**ADDENDUM NO. 1
UNION STREET IMPROVEMENTS
CITY OF CONCORD, NORTH CAROLINA**

This Addendum No. 1 is issued this 20Th day of August 2020 to all parties who hold a set of Bidding Documents for the project entitled “Union Street Improvements, Concord, North Carolina”. This Addendum No. 1 shall become part of the Contract Documents and its receipt acknowledged on the Bidding Documents at the time of bidding.

SHEET
CE-106

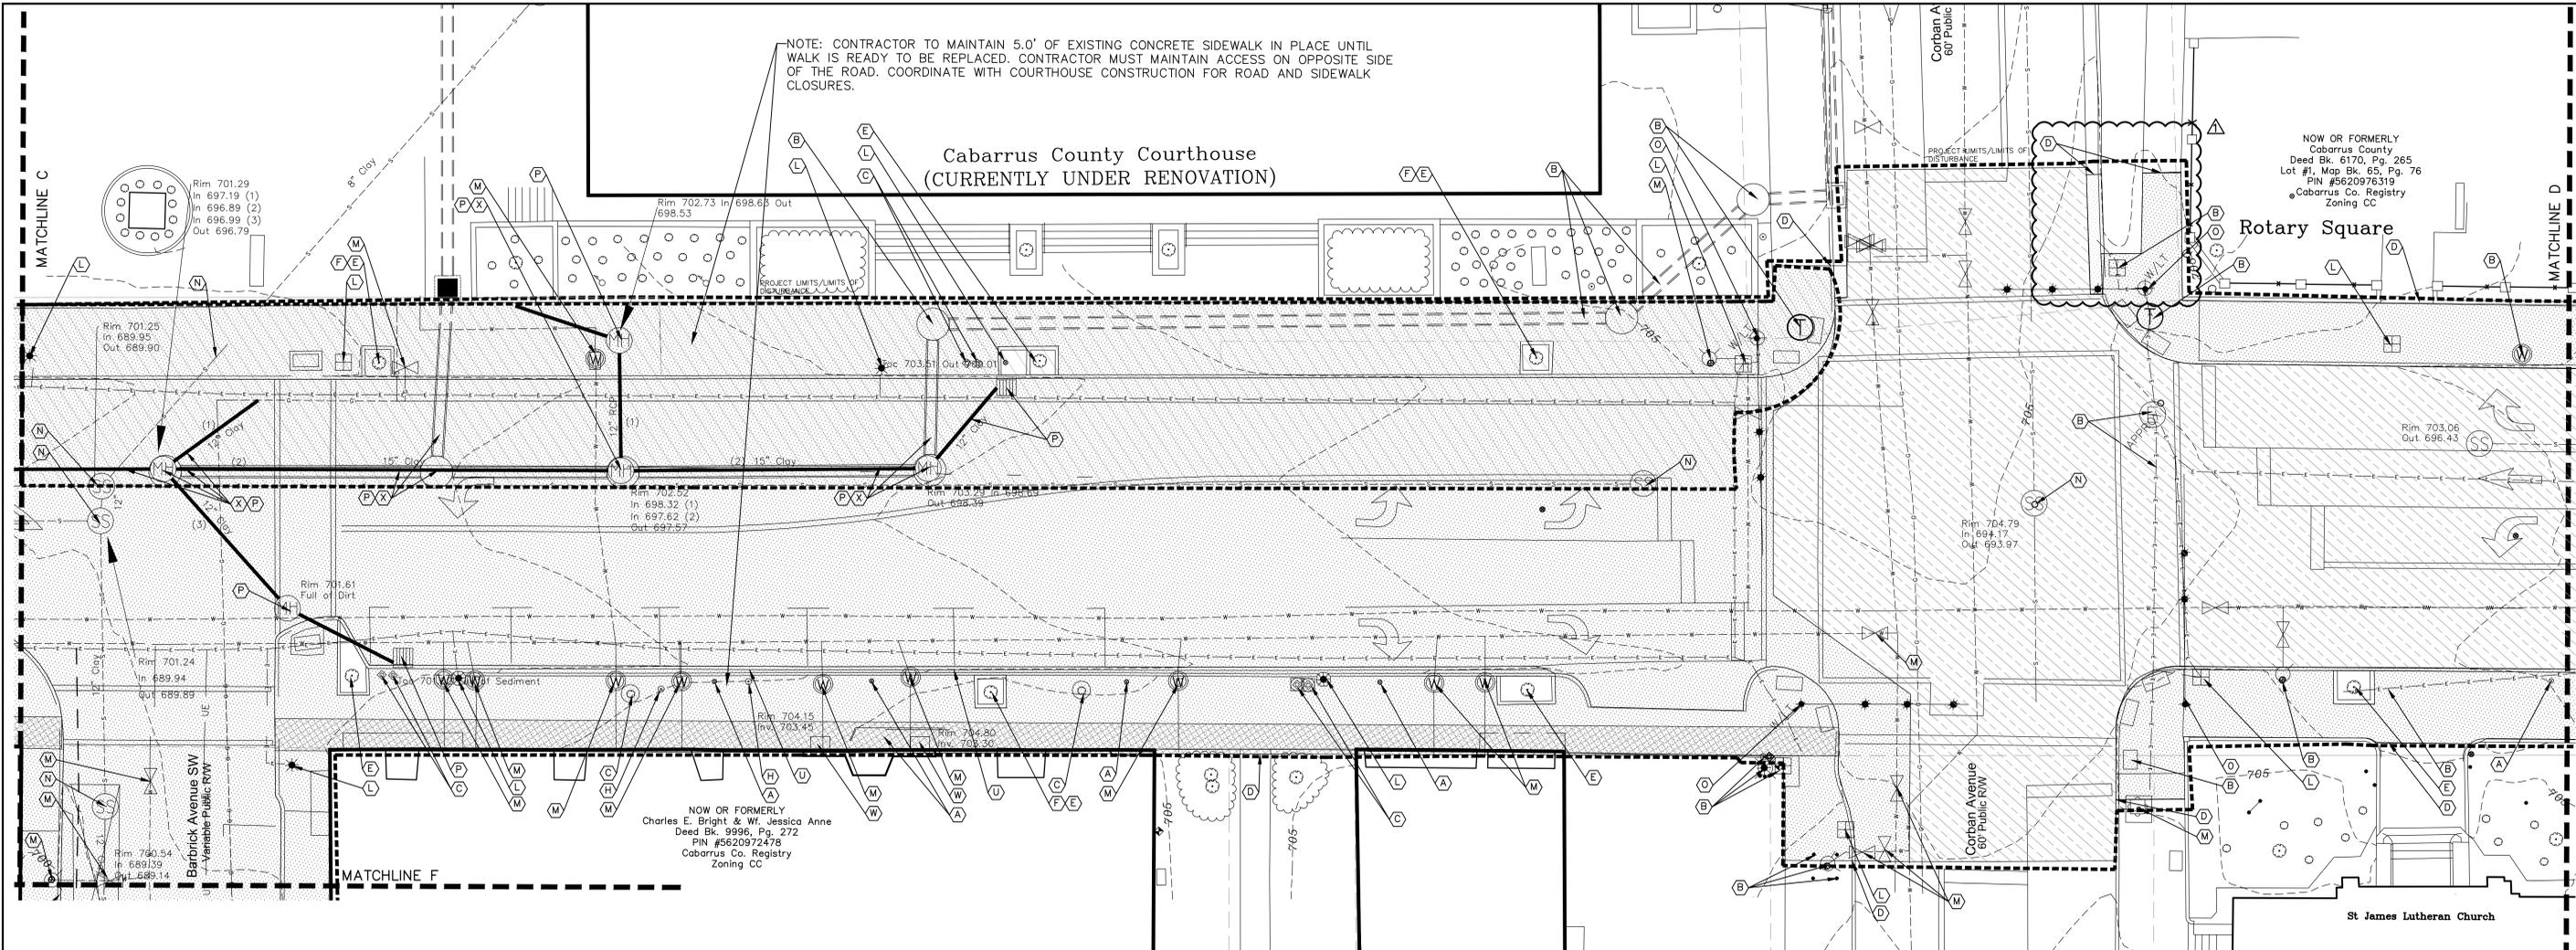
CE-106 – Add field located 4” roof drain not on survey

SHEET
CD-104

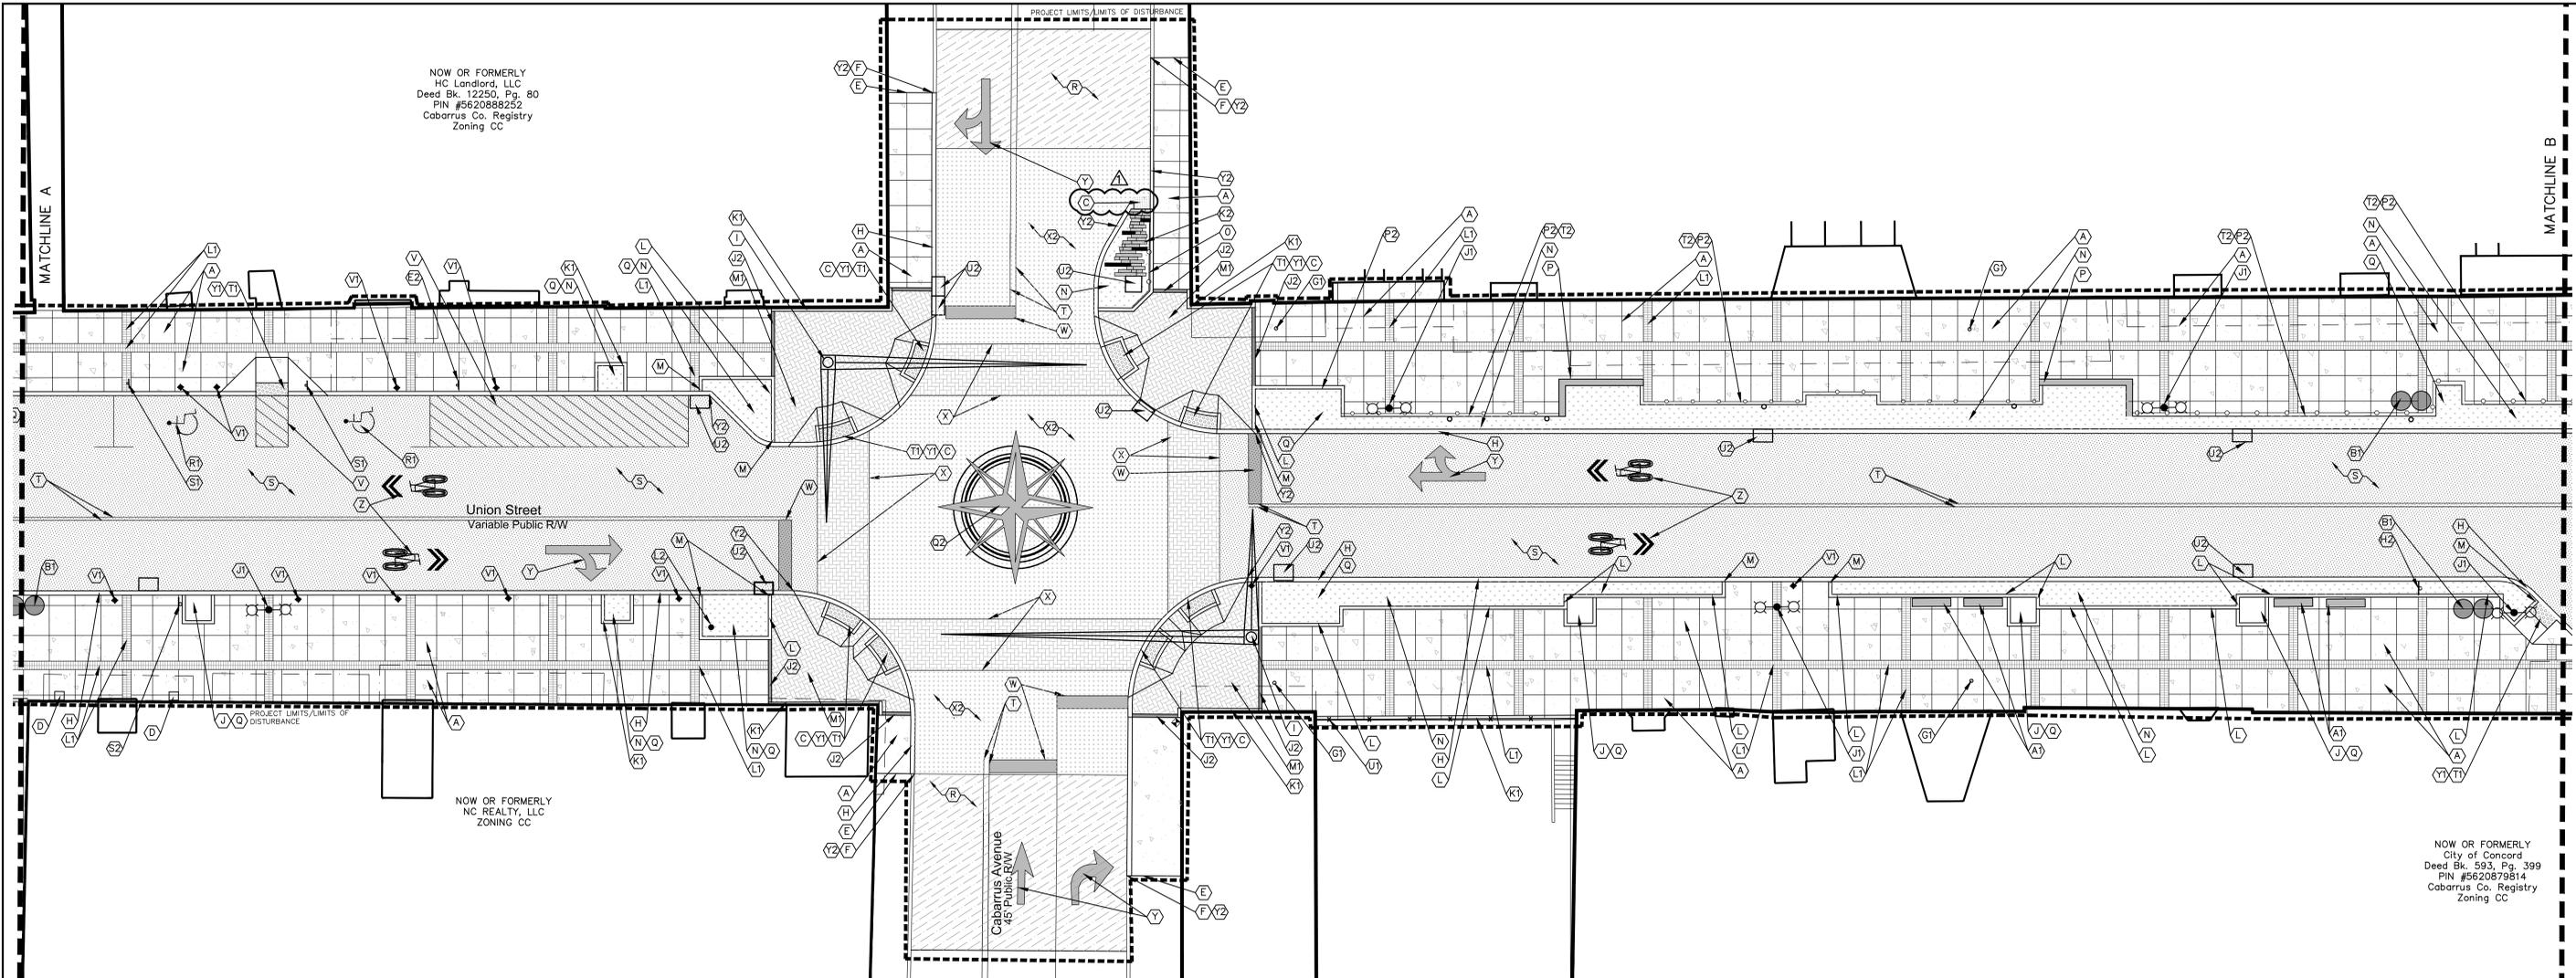
CD-104 – Added demolition of existing curb and gutter

SHEET
C-102

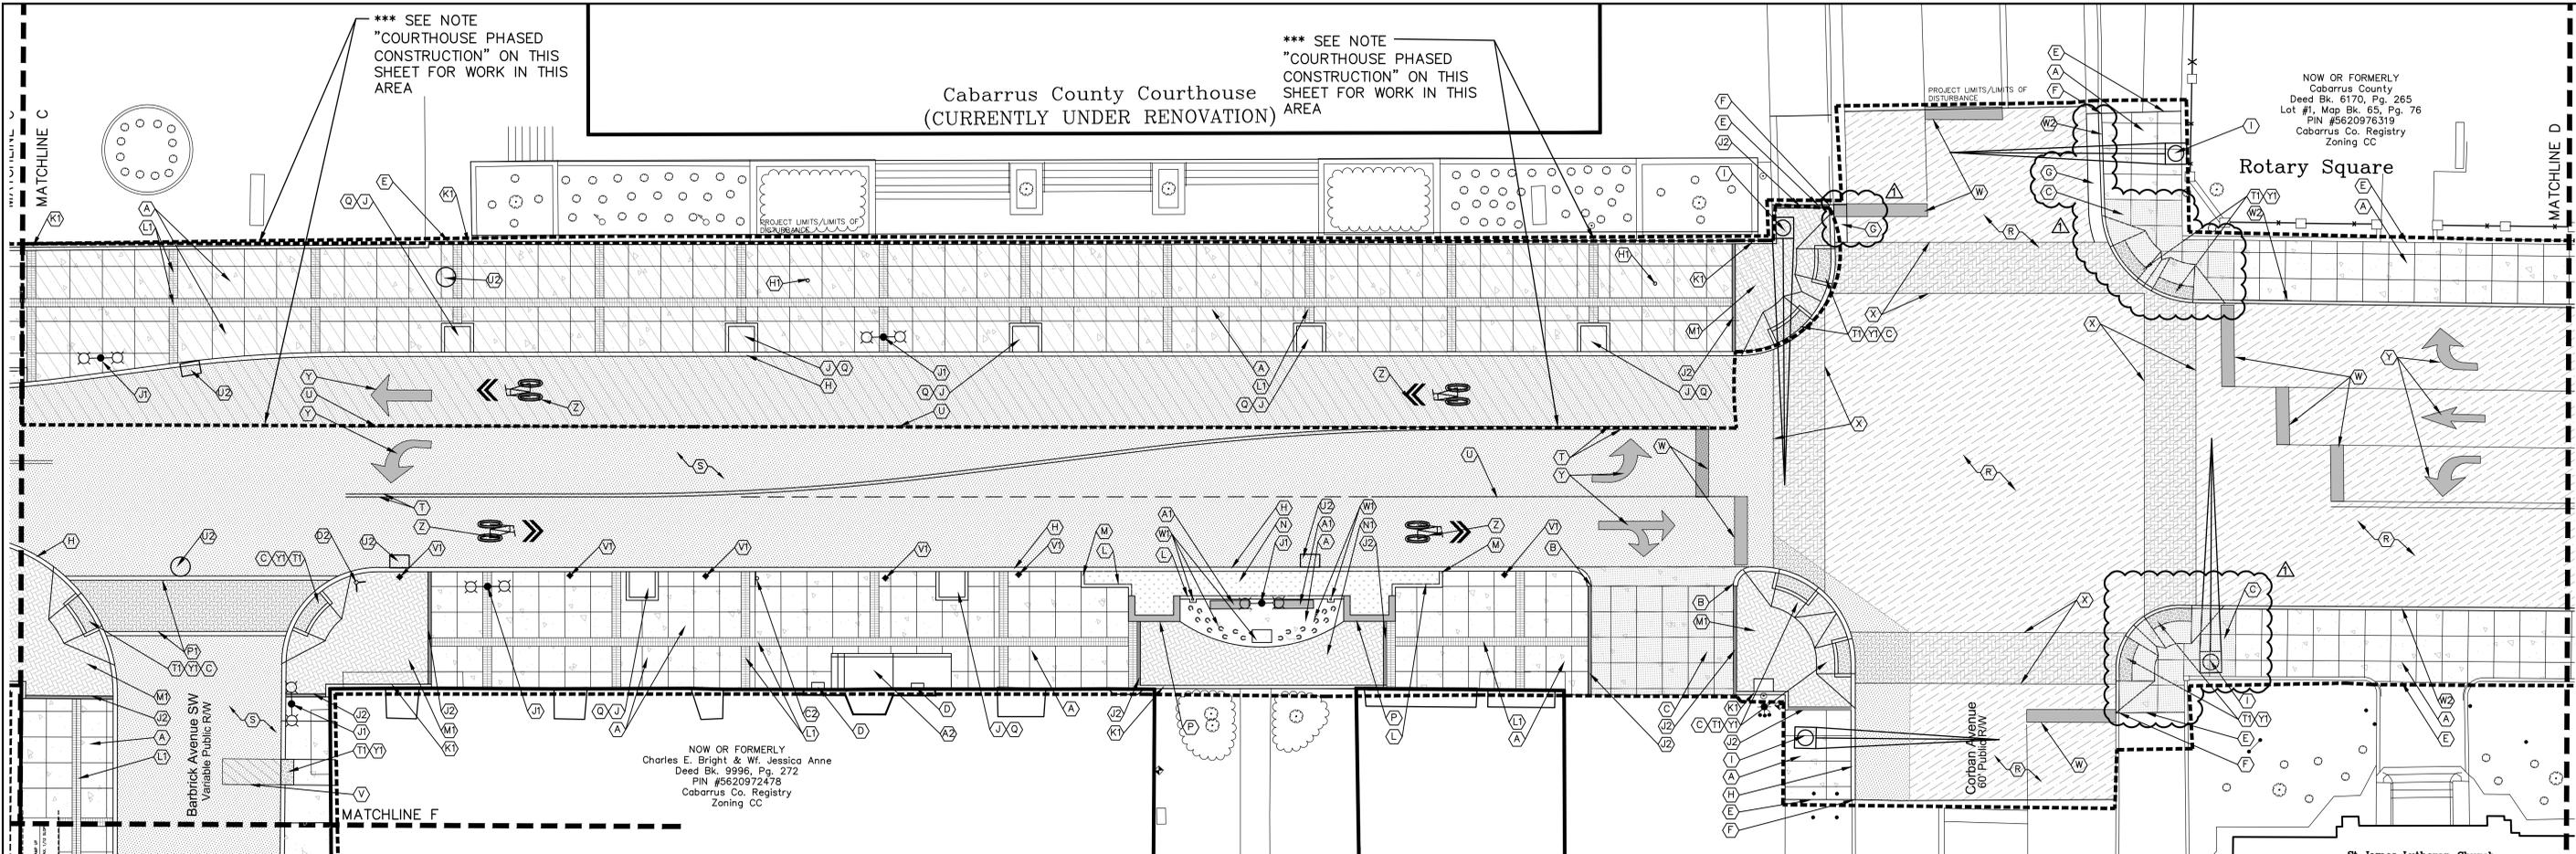
C-102 – Add key tag for 6” concrete section at end of granite SW flume

**SHEET
C-204**

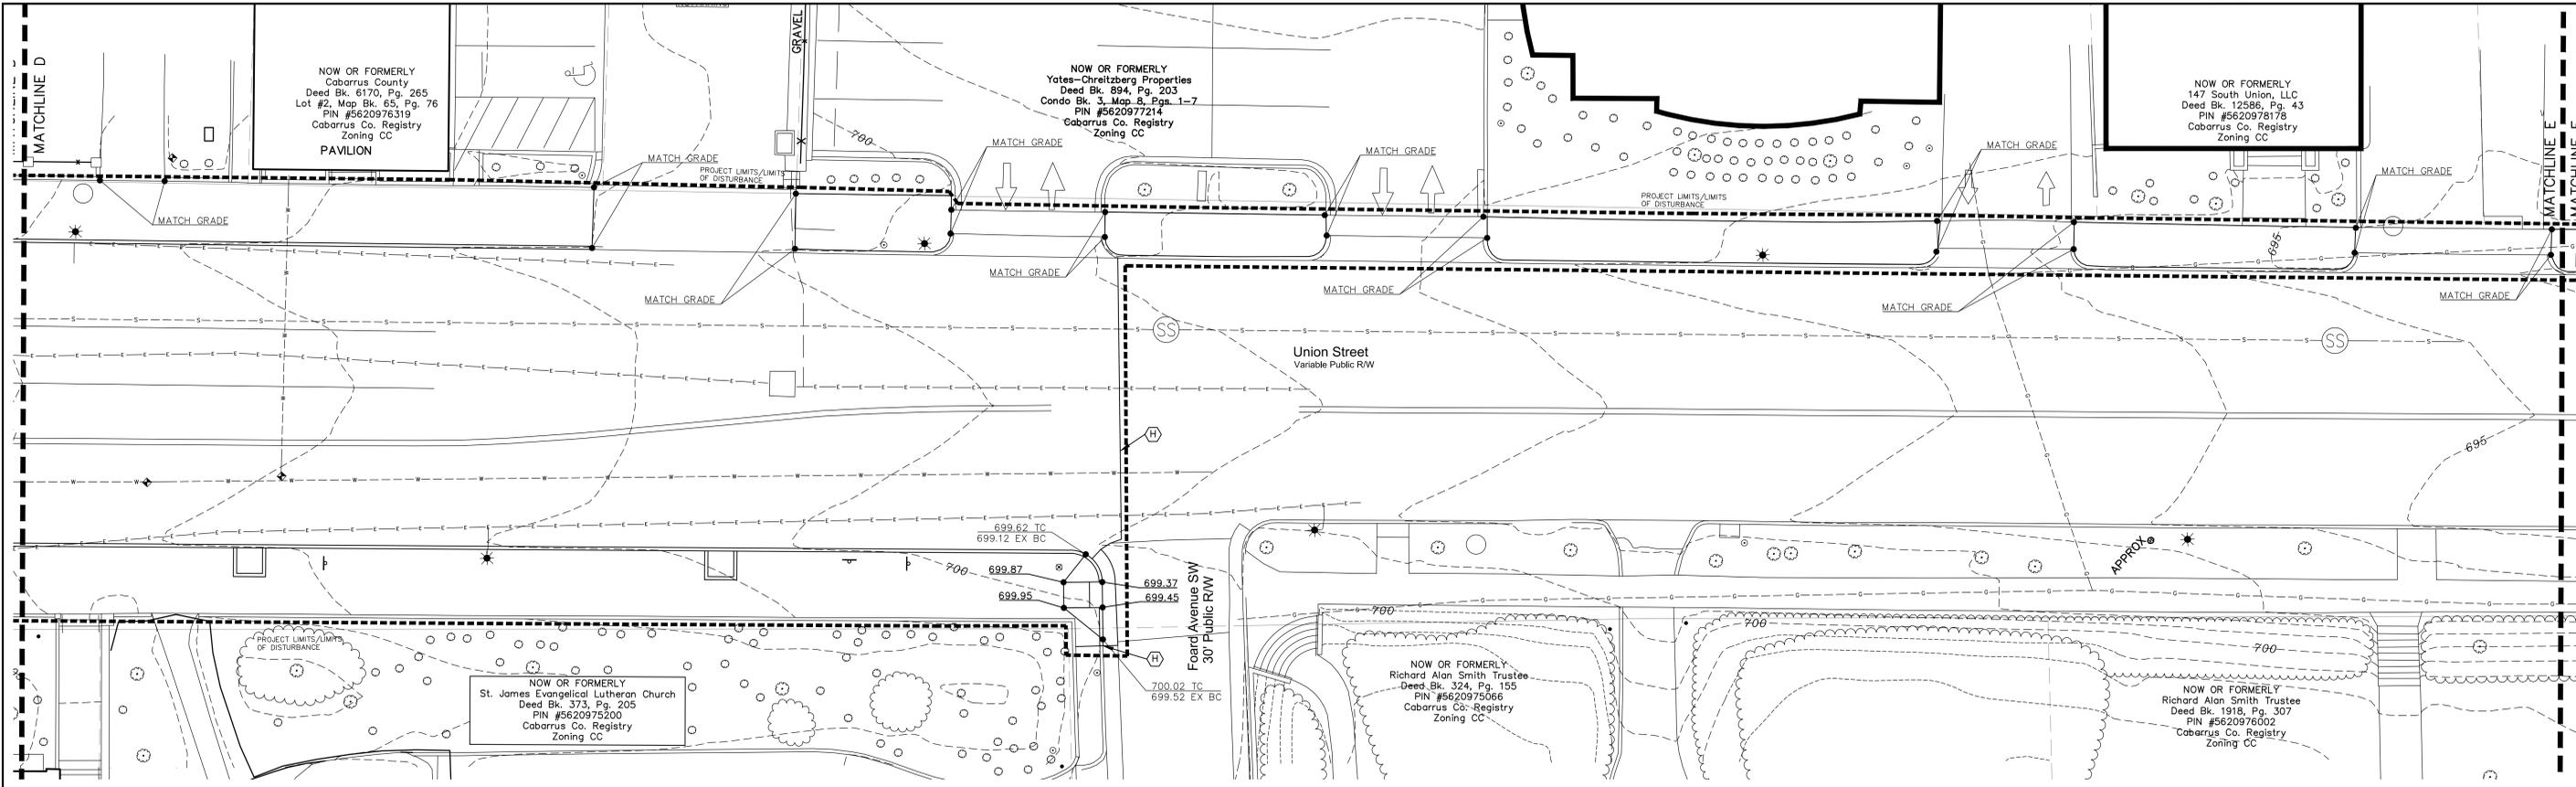
C-203 – Key notes revised
C-204 – Add 3" roof drain, update key notes
C-205 – Key notes revised
C-206 – add 4" and 6" roof drain, update key notes
C-207 – Key notes revised

8 TRAIL MARKERS
 REVISED FOR THIS PROJECT
 NOT TO SCALE

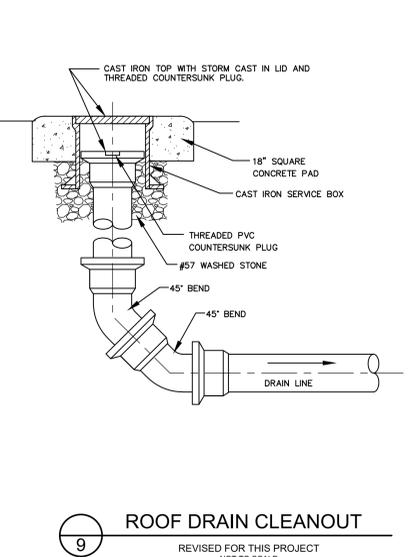
C-501 – Revised landscape edge and stand-up curb details
C-503 – Revised HC ramp side elevation
C-504 – Revised trail marker detail
C-506 – Revised monolithic wall detail
